Appendix I – Road Safety Audit Designer’s Responses

Adastral Park, Ipswich : Traffic Signals Access off the A12 Dual Carriageway

Technical Note : Designer's Response to Road Safety Audits at Stage 1

14th June 2017

Appendix B: Updated Design Drawing

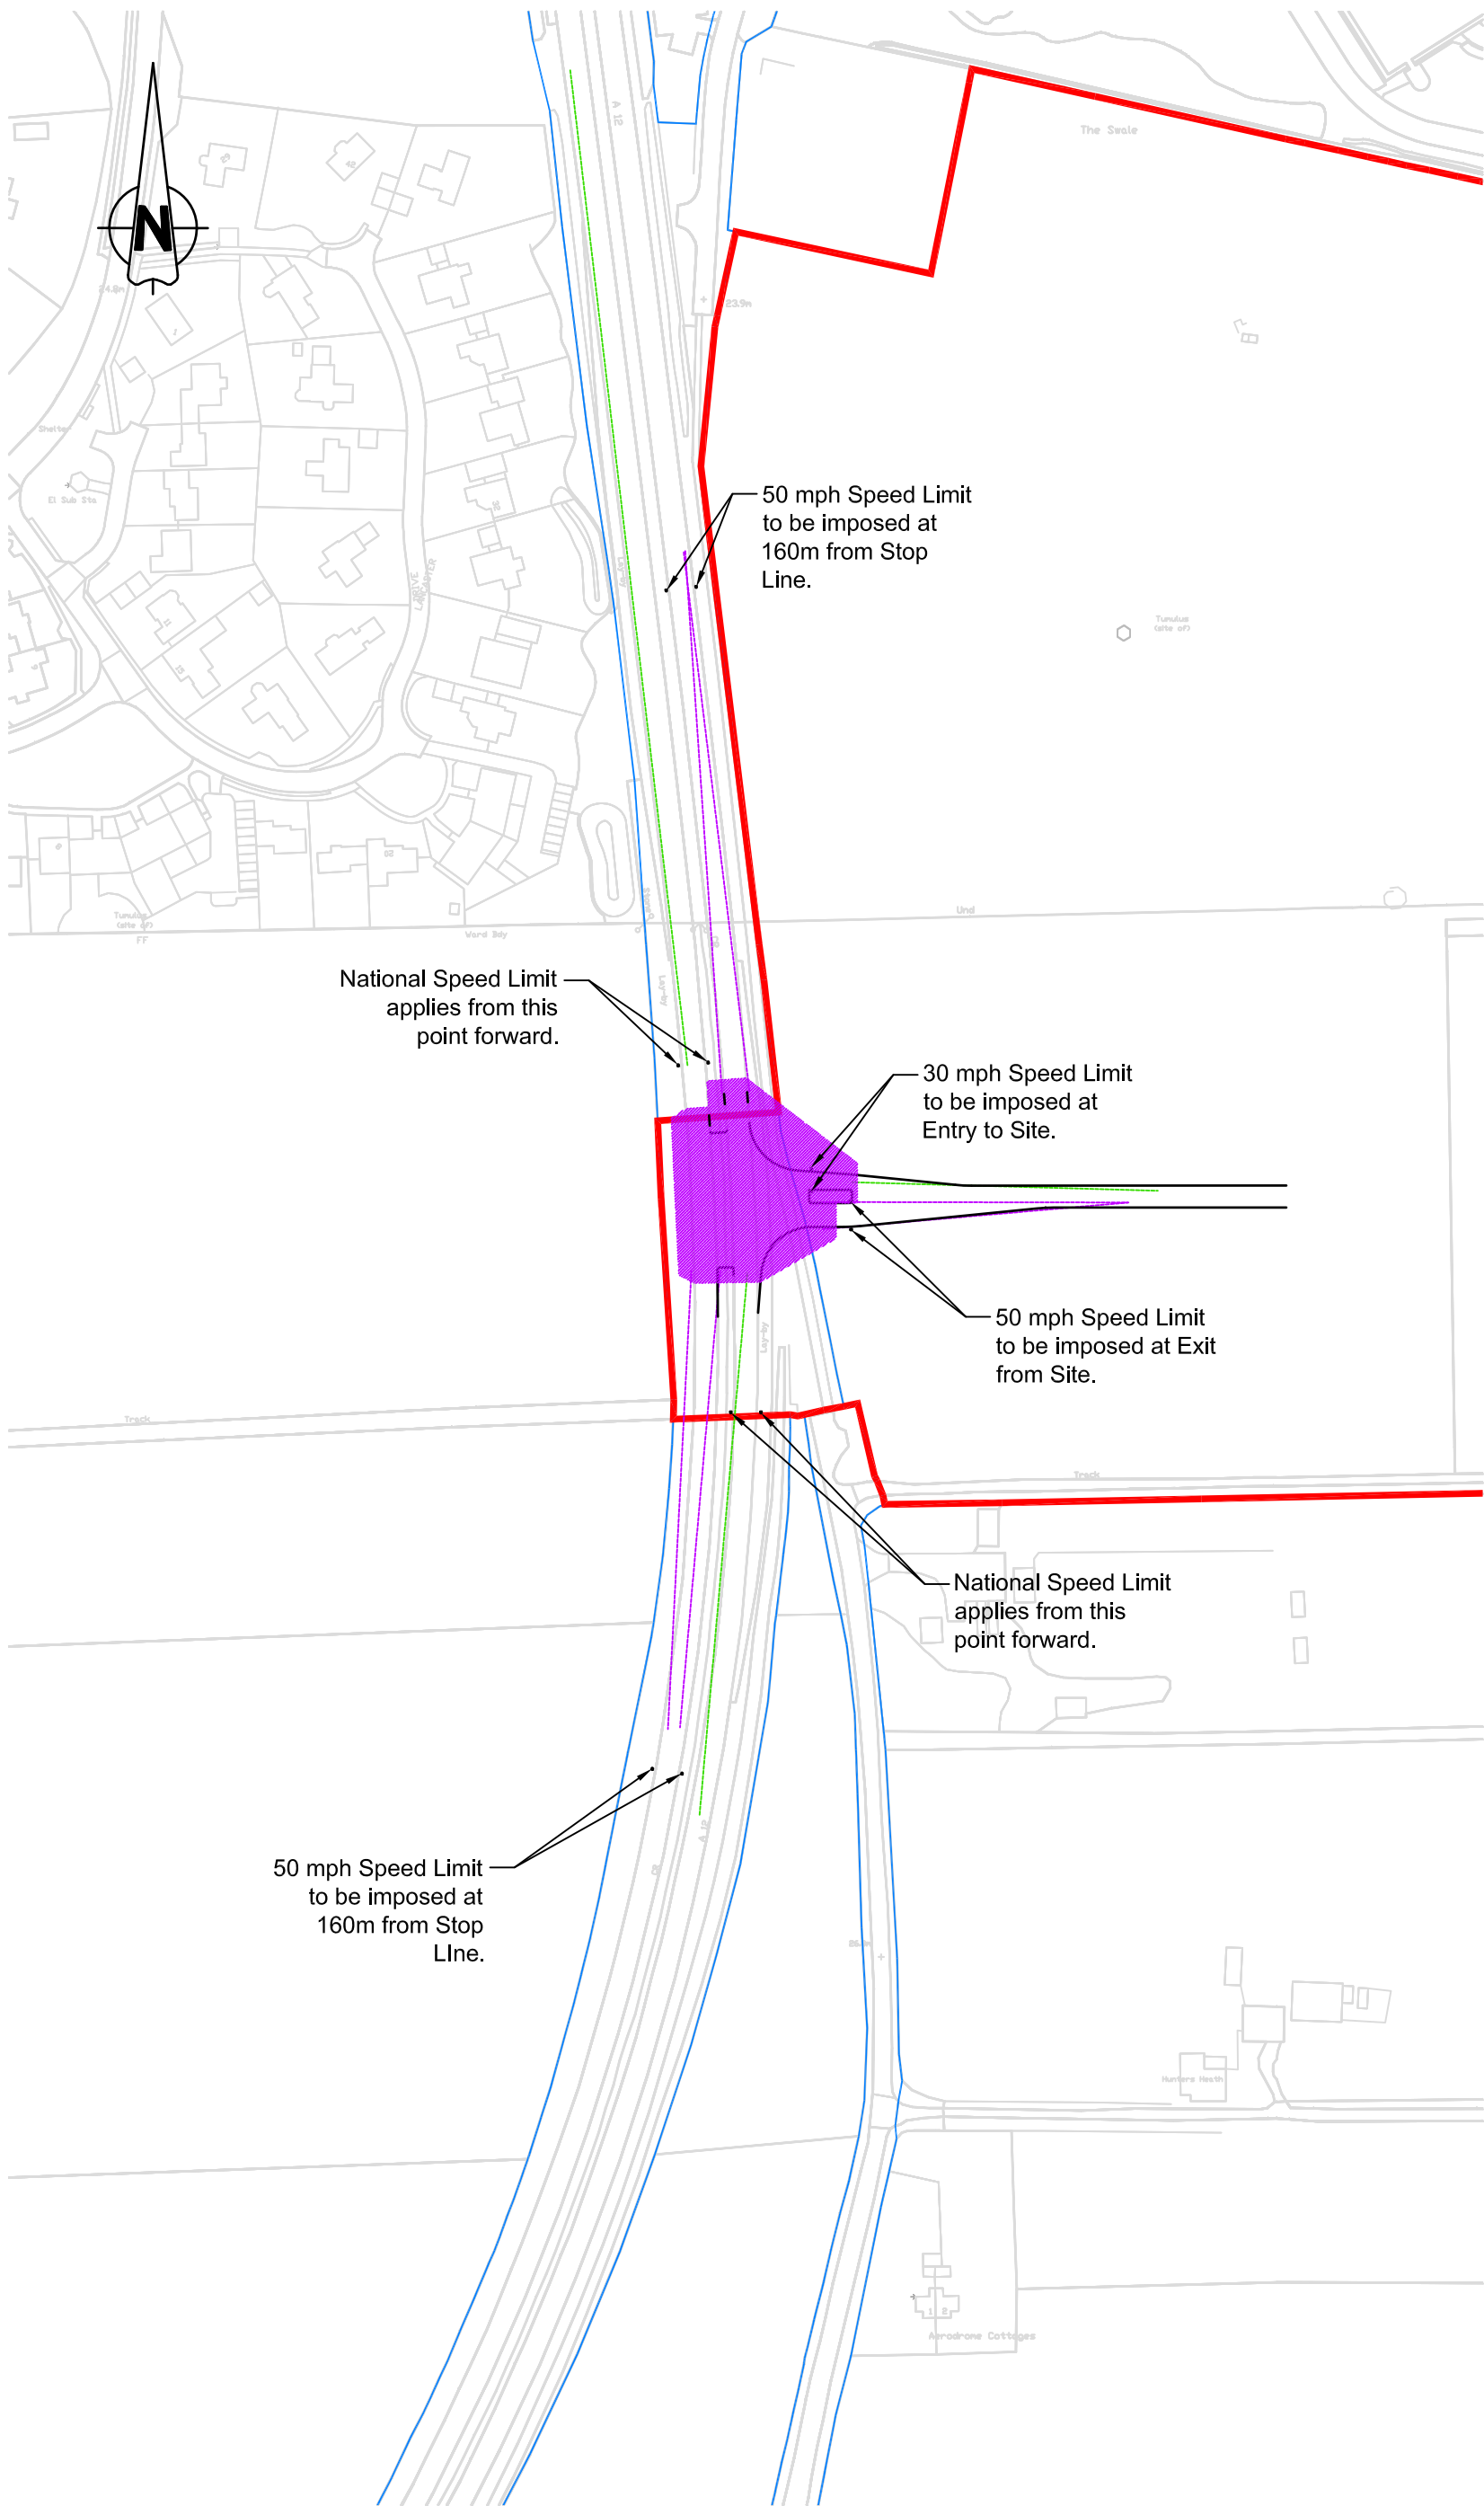
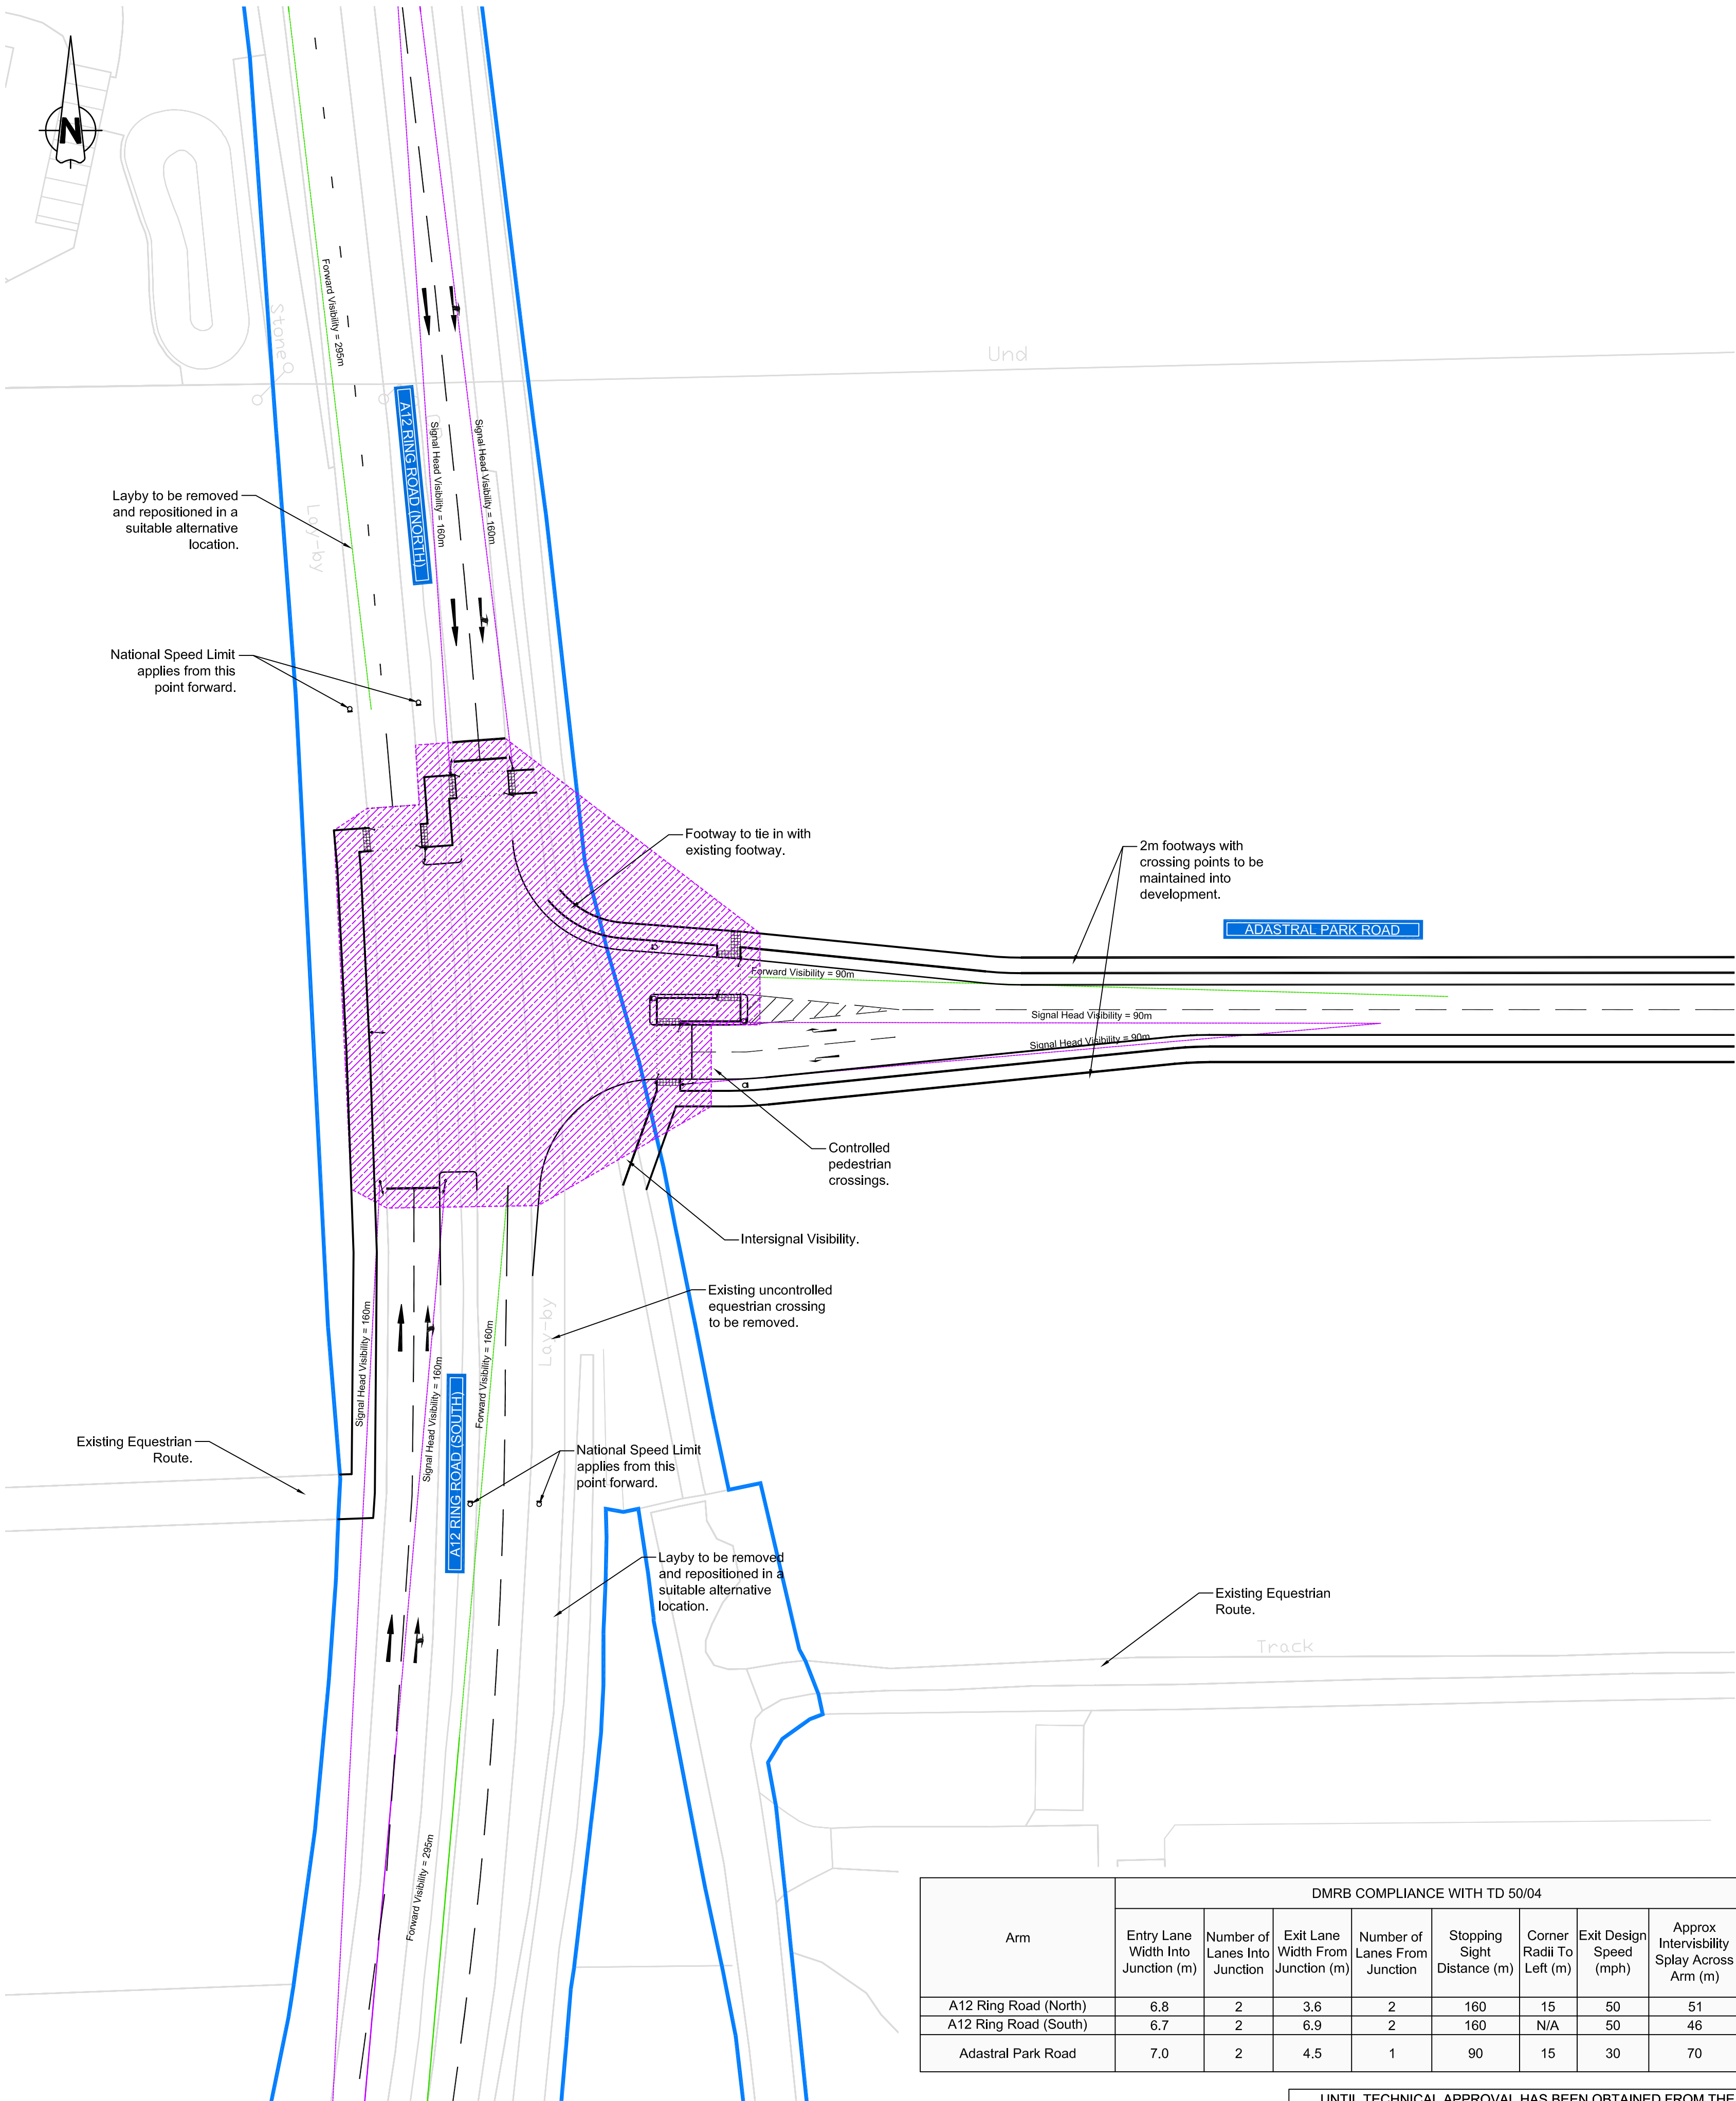
Summary: Risk of shunts/lane change accidents. It is not clear if there is sufficient room to accommodate right turners into Adastral Park Road. On this dual carriageway, drivers in the offside lane may be obstructed by right turning vehicles, which could result in shunts, or lane change accidents for drivers moving into the nearside to avoid the queuing vehicles, or vehicles slowing down to manoeuvre.

Recommendation: Provide an additional lane for right turning vehicles, or at detailed signal design ensure that all arms run separately.

Recommendation: Provide a smoother transition.

BCL Comment: *There is not sufficient space for an additional right-turning lane. However, at in terms of the signal phasing all arms shall run in separate stages, hence without having to Give Way to one another. This shall also apply to right-turning traffic from the A12 into Adastral Park Road.*

BCL Comment: *The transition has now been amended to provide a smoother transition on exit from the junction.*
